**PUBLIC UTILITIES COMMISSION**505 VAN NESS AVENUE
SAN FRANCISCO, CA 94102-3298**FILED**08-15-08
11:08 AM

Order Instituting Rulemaking to Establish
Uniform Construction Standards for Pole-Top
Antennas.

Rulemaking 07-12-001
(Filed December 6, 2007)

**DECISION ADOPTING UNIFORM CONSTRUCTION
STANDARDS FOR POLE-TOP ANTENNAS**

~~Figure 94.4~~

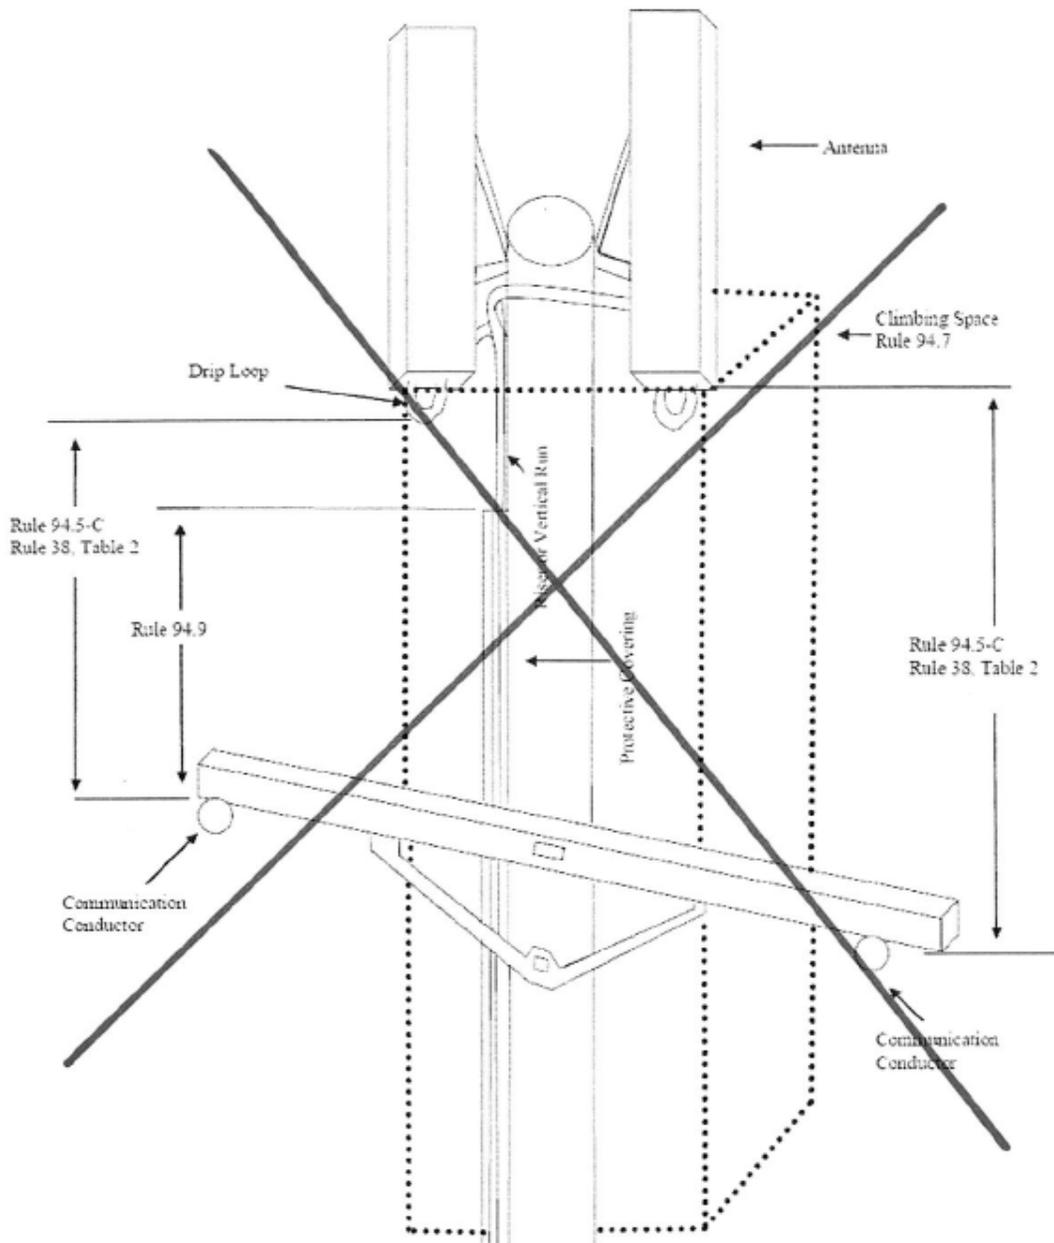
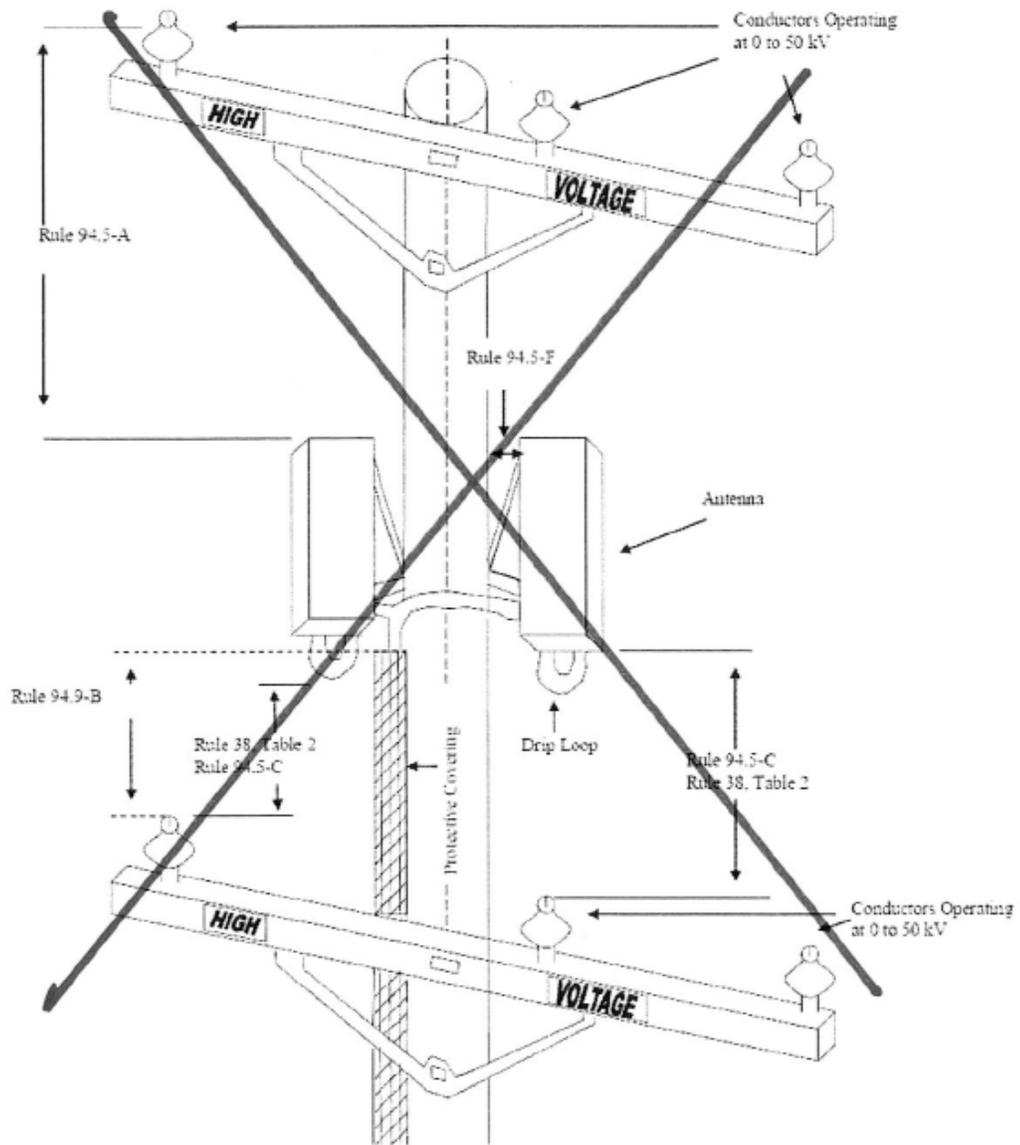
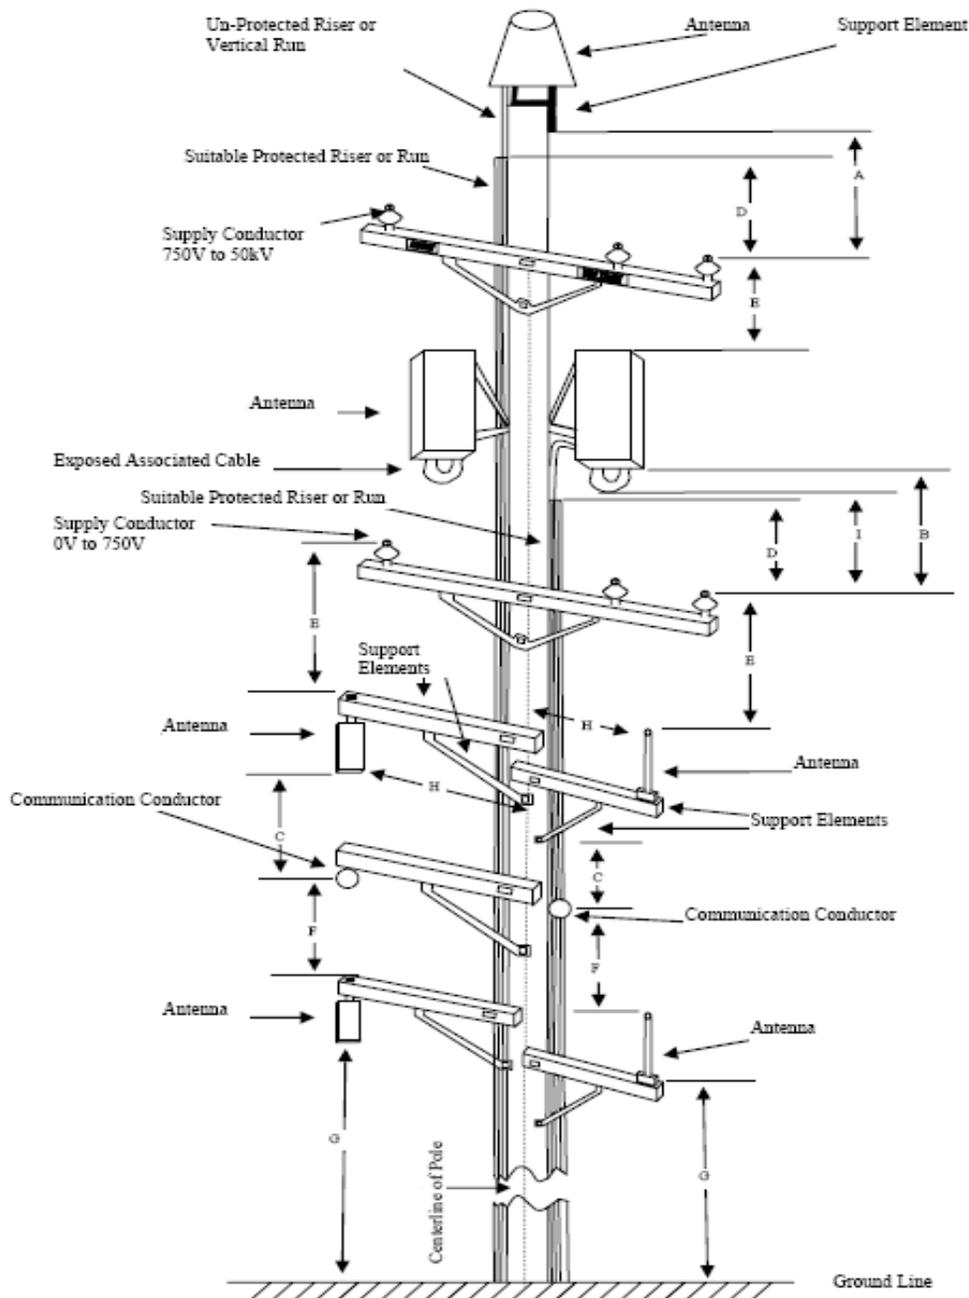
Finally, the TCR proposes to replace four existing diagrams with one new diagram labeled Figure 94.1. The new diagram illustrates in one place all of the vertical and horizontal clearances mandated by the revised Rule 94.

During the afternoon session, attendees discussed revisions to Figures 94.1 - 94.5 and concluded that a new Figure that encapsulates the variety of wireless antenna installations above and below supply and communication lines on a joint-use utility pole would be preferable to five separate Figures.

Also, the references to multiple Figures (94.1 – 94.5) were replaced with references to a new composite Figure 94.1.

(PRC #2) and Rule 92.1-F2 (PRC #3). Before adjourning, Raymond Fugere (CPSD) offered to revise the Figures 94.1 - 94.5 and Sam Stonerock (SCE) offered to organize the proposed workshop revisions to PRCs 1-4. Both the Figures and revisions were subsequently distributed to the Parties.

Figure 94-1

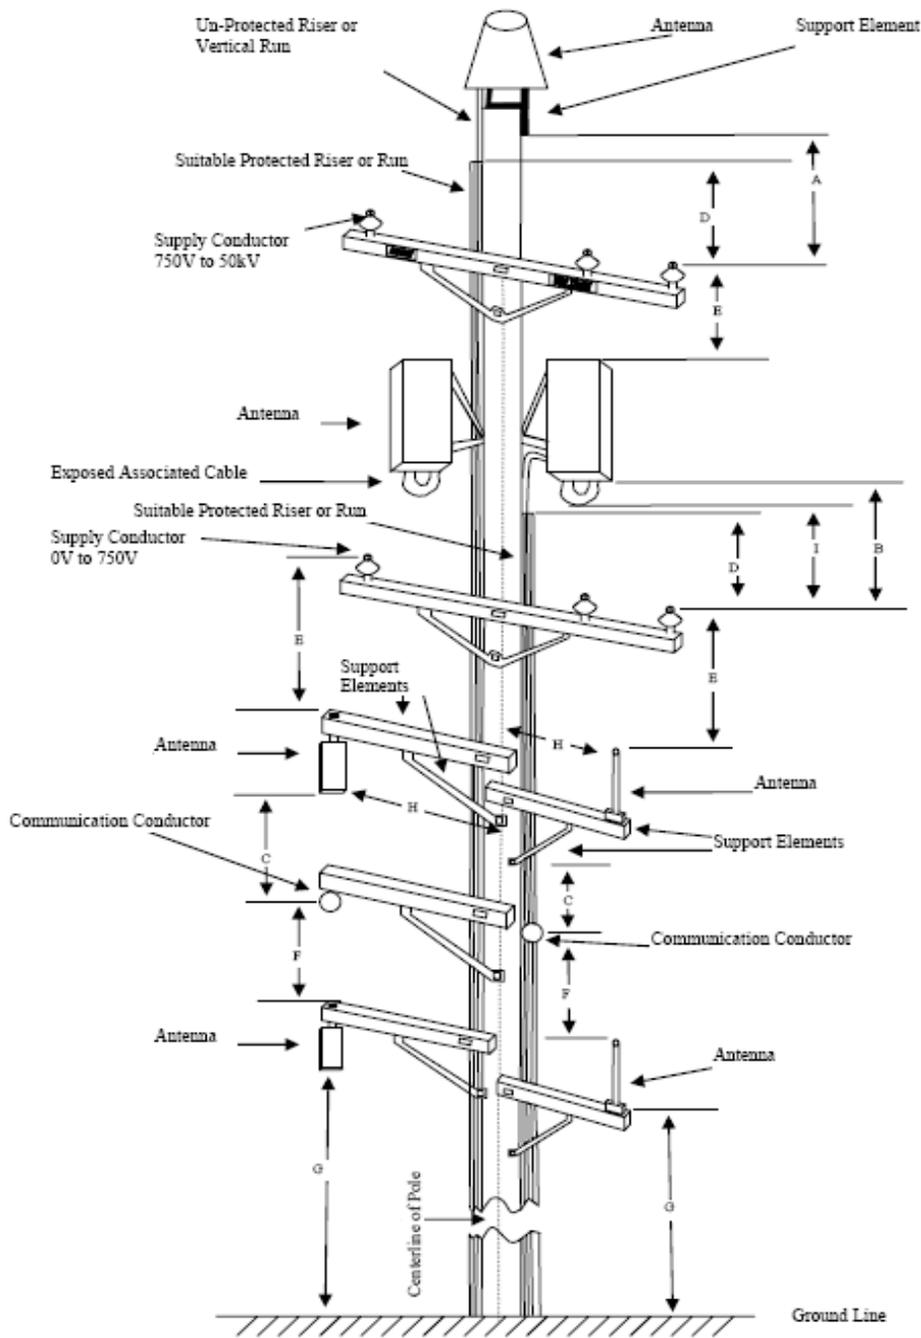
B. The suitable protective covering (see Rule 22.8) for risers and vertical runs passing supply lines and/or equipment shall extend no less than (see Figure 94.1):

- (1) 3 ft. above lines energized from 0 – 750 Volts.
- (2) 6 ft. above lines energized from 750 – 35,000 Volts.
- (3) 9 ft. above lines energized from 35,000 – 50,000 Volts.
